Landscape Review Committee
Community Development Center, 231 NE 5th Street
August 21, 2019
12:00 PM

DATE: August 21, 2019
TO: Landscape Review Committee Members
FROM: Jamie Fleckenstein, Associate Planner
SUBJECT: Landscape Plan Review Application (L 10-19)

DECISION, CONDITIONS, FINDINGS OF FACT AND CONCLUSIONARY FINDINGS FOR THE APPROVAL OF A LANDSCAPE PLAN AT 4155 NE THREE MILE LANE

REQUEST: Approval of a Landscape Plan for an RV Storage Lot

Figure 4: Proposed Landscape Plan

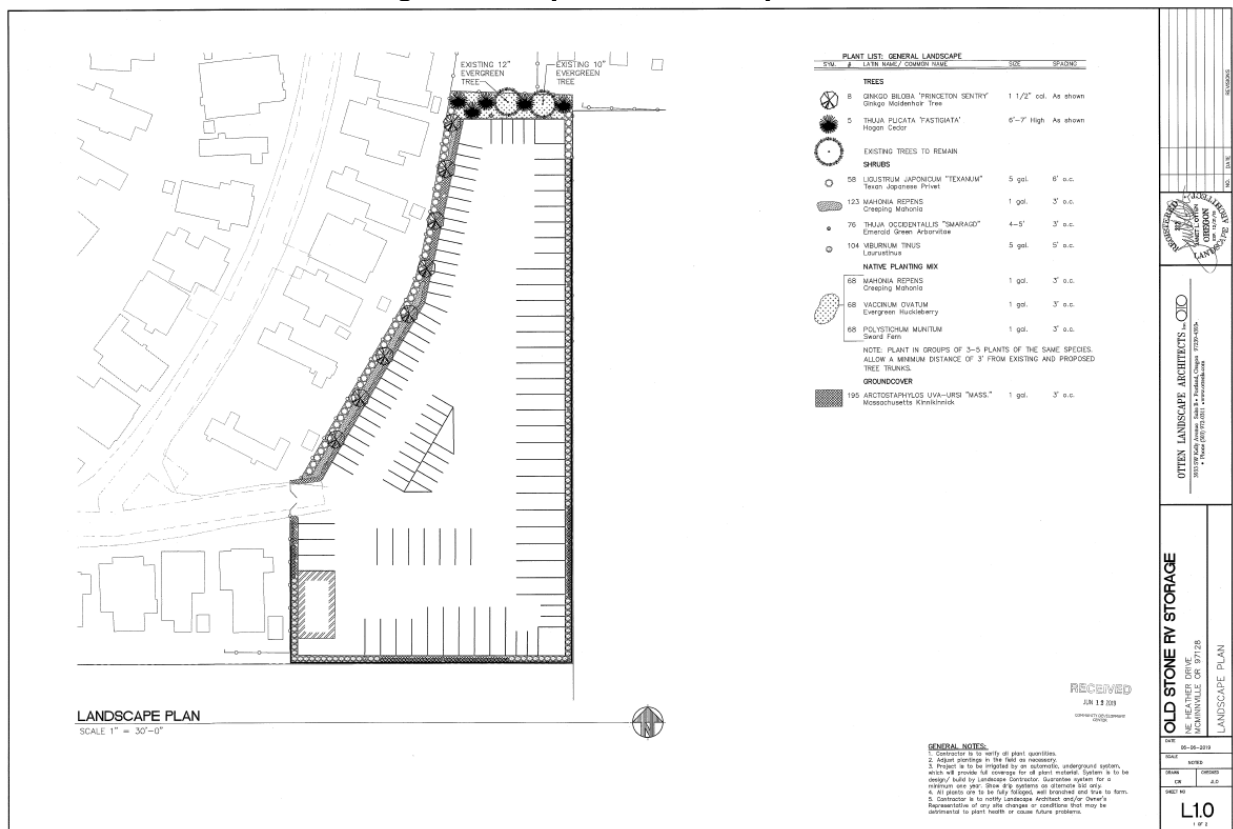
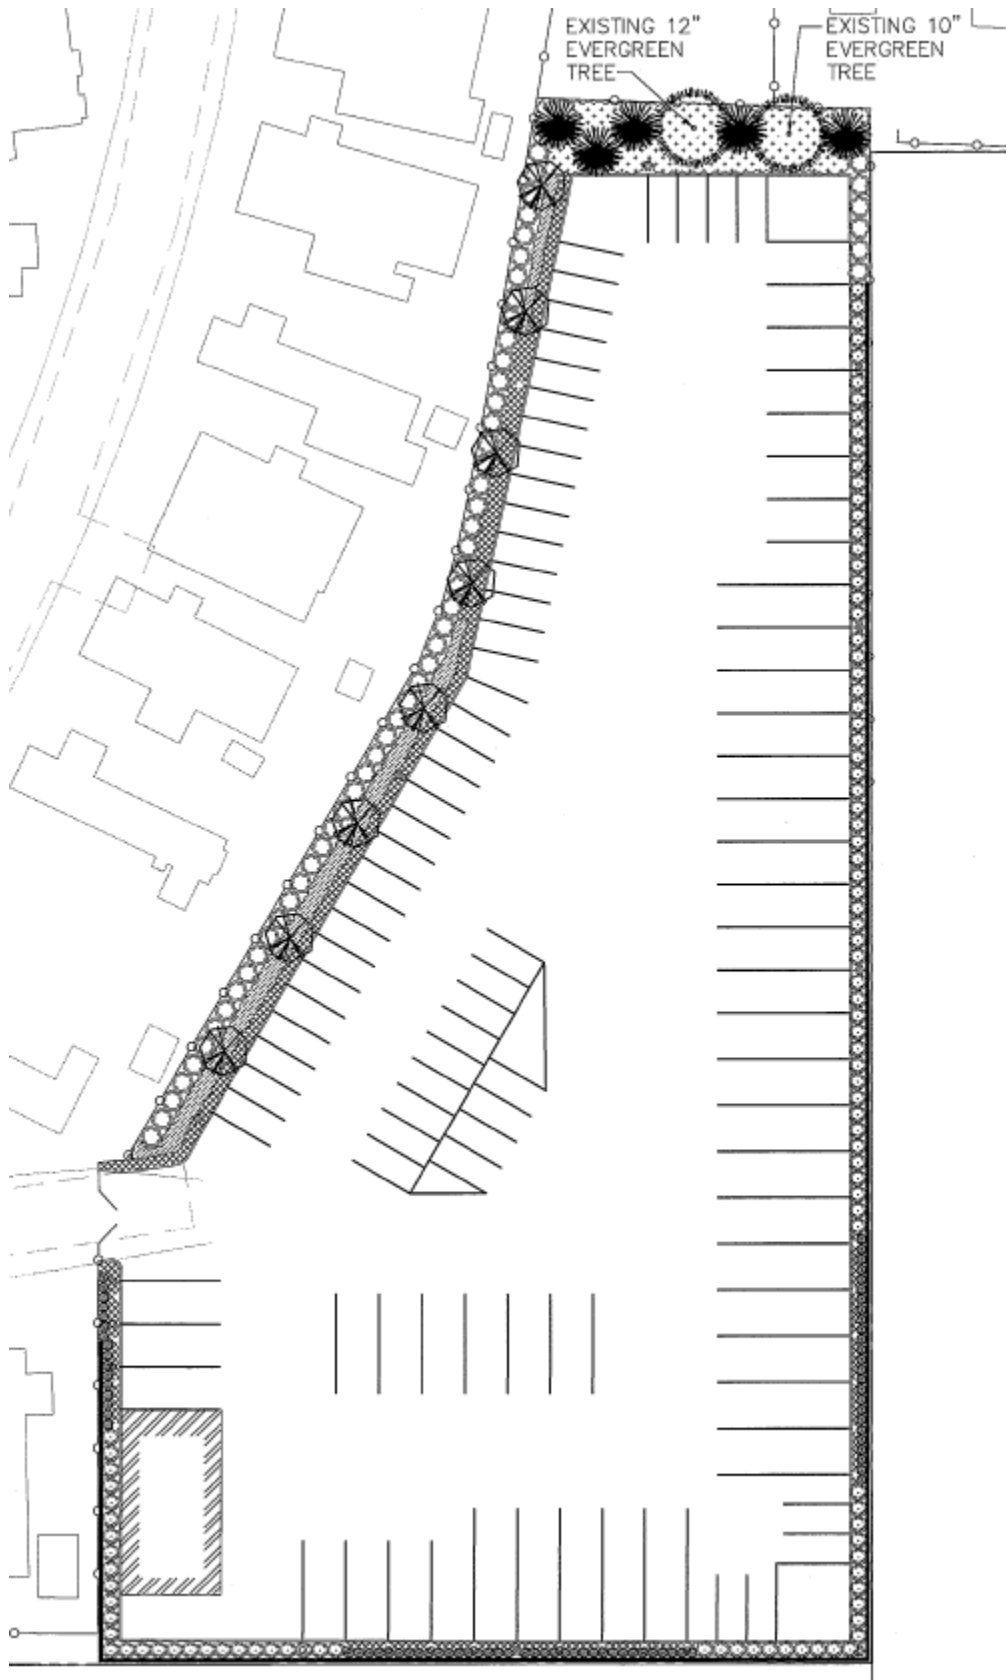
The one area where the proposed landscaping did not meet the purpose and intent of the landscaping chapter was the absence of planting interior to the parking lot to break up the paved areas. As previously discussed, the apparent conflict between the use and plantings in the interior of the parking area led to all landscaping being proposed around the perimeter. A condition of approval has been included to provide additional shade trees around the perimeter of the lot, helping the landscape achieve a stated intent of the code – to provide parking lot landscaping that reduces the harmful effect of heat, noise, and glare associated with motor vehicle use.

East and south of the subject site are undeveloped lots that are in agricultural use. Because these adjacent lots are undeveloped, the subject site is visible from Highway 18 at its westbound entrance into McMinnville. No trees are proposed along the south and west edges that would provide shade to the parking lot, but tall evergreen hedges along the east and south property lines would provide visual screening and buffering of the RV storage.

1. That shade trees be provided in the planting areas along the east and south property lines at a regular spacing appropriate for the tree species selection and that accommodates the utility and light standard locations.

2. That the applicant shall submit a revised landscape plan to the McMinnville Planning Department for review and approval that reflects conditions of approval.

Figure 4: Proposed Landscape Plan

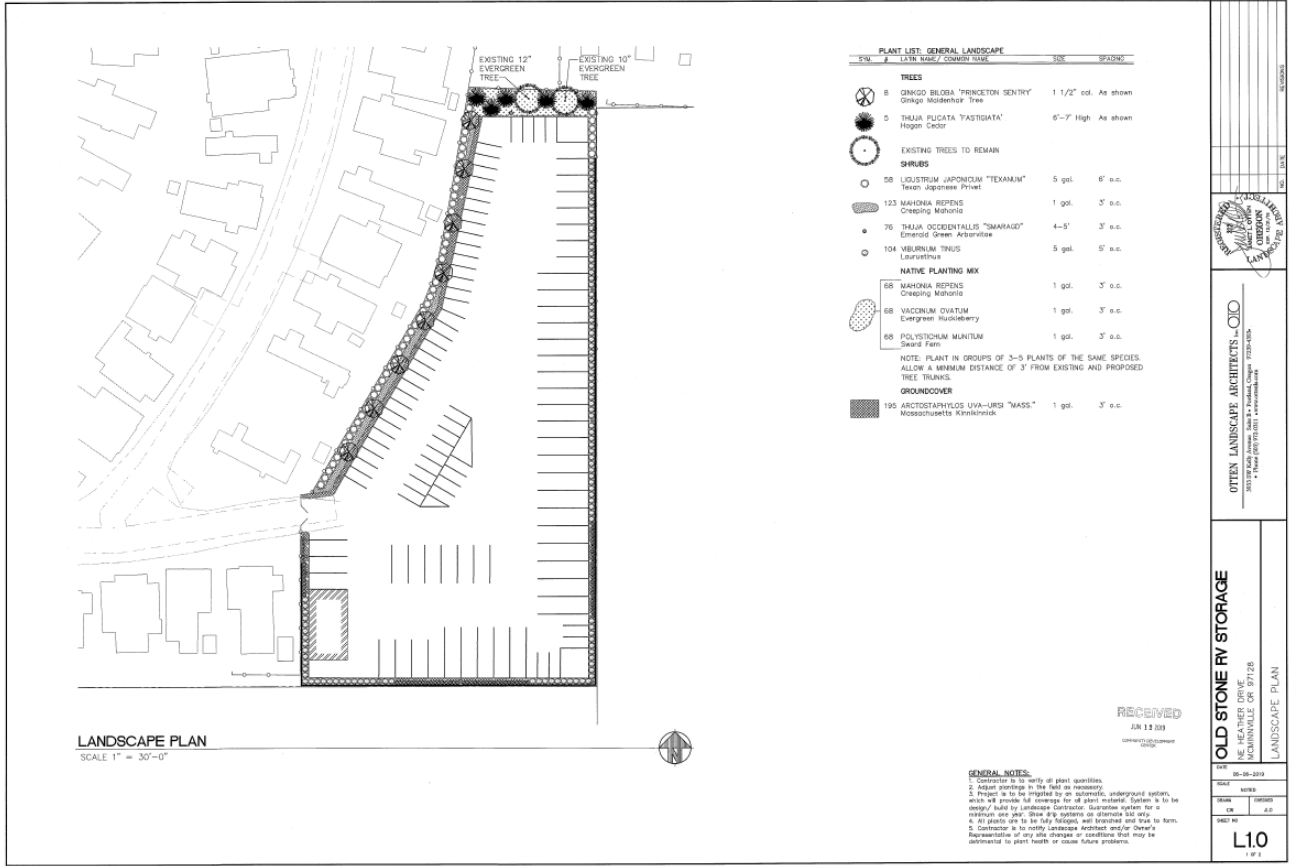
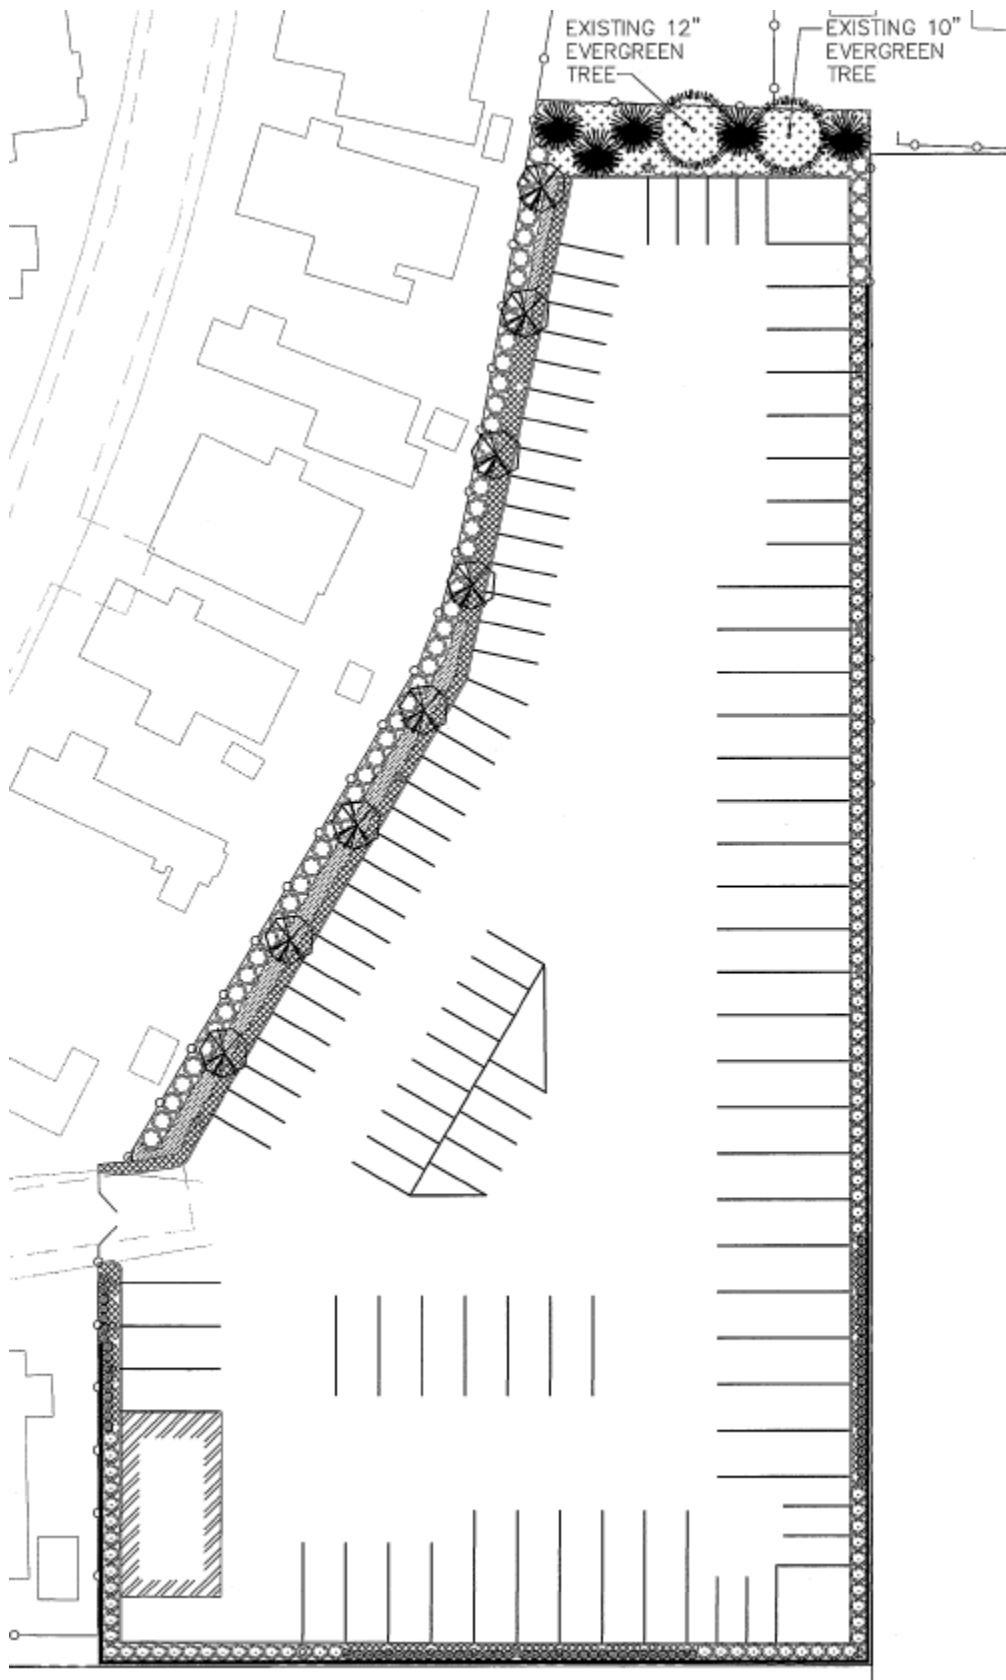
The one area where the proposed landscaping did not meet the purpose and intent of the landscaping chapter was the absence of planting interior to the parking lot to break up the paved areas. As previously discussed, the apparent conflict between the use and plantings in the interior of the parking area led to all landscaping being proposed around the perimeter. A condition of approval has been included to provide additional shade trees around the perimeter of the lot, helping the landscape achieve a stated intent of the code – to provide parking lot landscaping that reduces the harmful effect of heat, noise, and glare associated with motor vehicle use.

3. That the applicant shall maintain proper clearances around the existing and future water and electrical services that will be located on the site. Landscaping shall not be placed within four (4) feet of fire hydrants, within four (4) feet of water valves, within four (4) feet of vaults, within three (3) feet of the back or side of a transformer, or within one (1) foot of water meters. Minor adjustments in plant placement from the locations shown on the approved landscape plan are allowed if relocation is necessary to meet minimum clearances.

Figure 2: Applicant's Proposed Site Plan

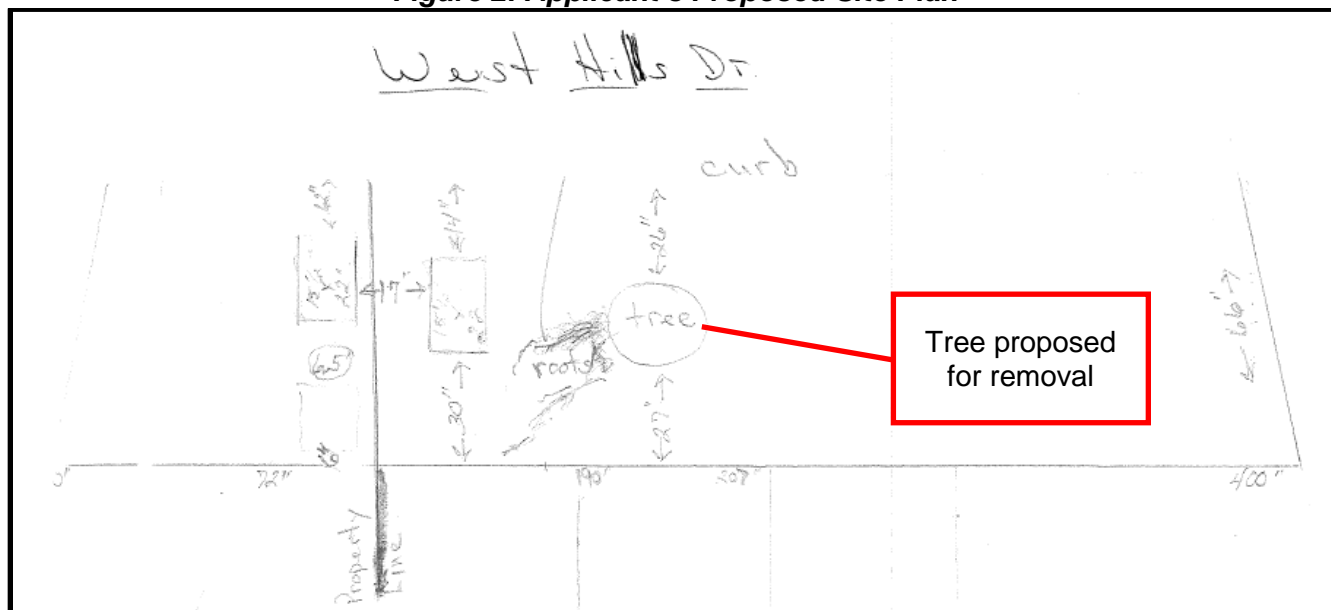
The applicant has requested the removal of one (1) street tree because of conflict with public improvements. The subject street tree is adjacent to the property at 457 SW West Hills Drive in the Hillsdale First Addition subdivision. There is no approved street tree plan for the Hillsdale First Addition. **See Figure 2 (Applicant's Proposed Site Plan).**

The subject tree is an *Acer rubrum* var. (Red Maple variety), approximately 9 inches in diameter at breast height (DBH) and approximately 25 feet in height. The tree is within approximately 10 feet of two (2) water meters, and exhibits extensive surface rooting in the direction of the water meters that has impacted the water meter boxes. **See Figure 3 (Surface Rooting).** Additionally, the surface roots had lifted the sidewalk panel adjacent to the water meters, causing a significant surface discontinuity and trip hazard in the path of travel. A crack is present in the curb adjacent to the tree. The sidewalk panel has since been replaced, though the tree root(s) appear to remain below the new panels. **See Figures 4 and 5 (Street Tree Conflicts – Before Repair) and Figure 6 (Street Tree Conflicts – After Repair).** A utility vault straddles the common property line, and the damage to the nearby water meters and the adjacent sidewalk would suggest that the underground utilities are also at risk for conflict from the tree roots. **See Figure 7 (Utility Vault).** Although the damaged sidewalk has been repaired by replacing the panels, it is anticipated that the roots below the sidewalk would continue to grow and expand, impacting the new sidewalk as it had the previously damaged sidewalk and potentially the utility vault. The roots appear to

be impacting both nearby water meters boxes. Therefore, this request would meet the review criteria for granting approval to remove a tree in conflict with adjacent public improvements.

Figure 2: Applicant's Proposed Site Plan

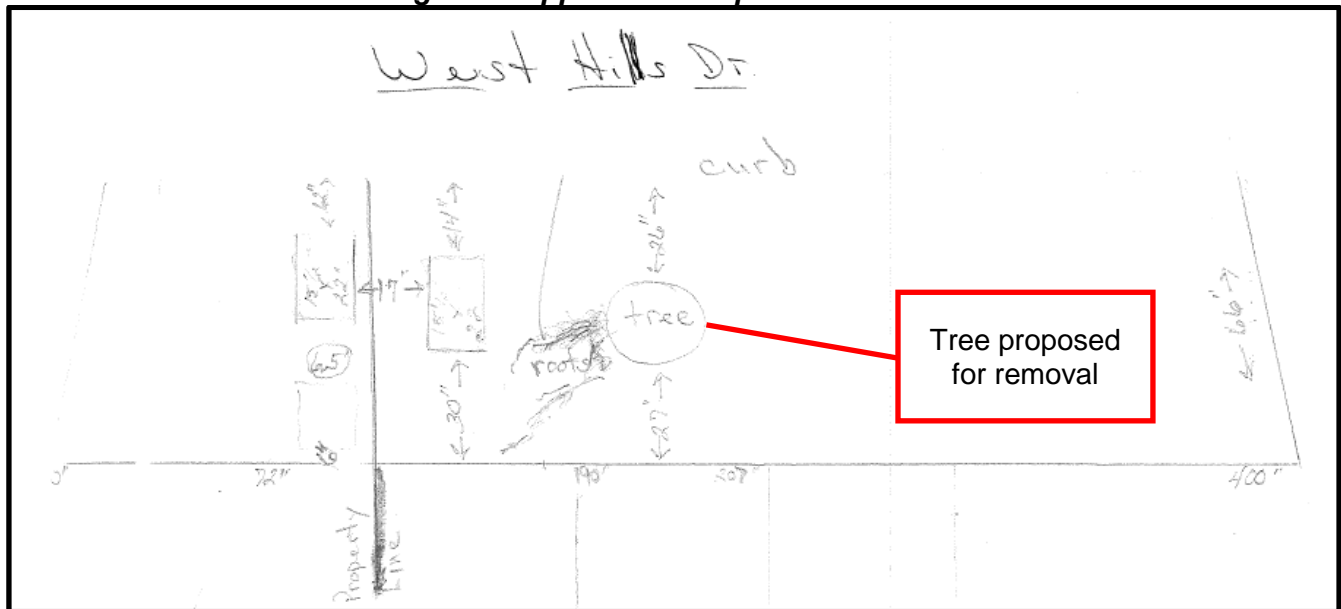
The applicant has requested the removal of one (1) street tree because of conflict with public improvements. The subject street tree is adjacent to the property at 457 SW West Hills Drive in the Hillsdale First Addition subdivision. There is no approved street tree plan for the Hillsdale First Addition. **See Figure 2 (Applicant's Proposed Site Plan).**

The subject tree is an *Acer rubrum* var. (Red Maple variety), approximately 9 inches in diameter at breast height (DBH) and approximately 25 feet in height. The tree is within approximately 10 feet of two (2) water meters, and exhibits extensive surface rooting in the direction of the water meters that has impacted the water meter boxes. **See Figure 3 (Surface Rooting).** Additionally, the surface roots had lifted the sidewalk panel adjacent to the water meters, causing a significant surface discontinuity and trip hazard in the path of travel. A crack is present in the curb adjacent to the tree. The sidewalk panel has since been replaced, though the tree root(s) appear to remain below the new panels. **See**
